UNITED STATES PATENT AND TRADEMARK OFFICE

Office Action Summary	Application No. 10/579,583	Applicant(s) RUDDUCK ET AL.	
	Examiner Jack W. Lavinder	Art Unit 3677

DETAILED ACTION***Claim Rejections - 35 USC § 102***

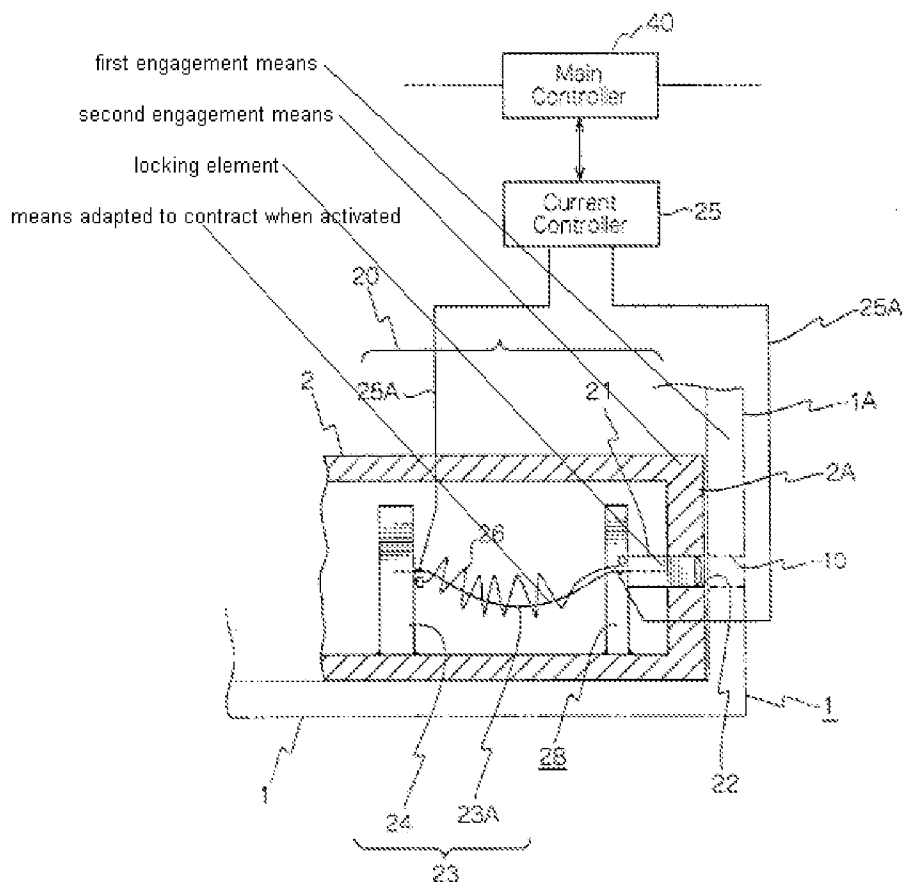
Claims 47 and 50 has been rejected under 35 U.S.C. 102(b) as being anticipated by Kawakami, 6008992.

Kawakami discloses the invention as shown in the annotated drawing.
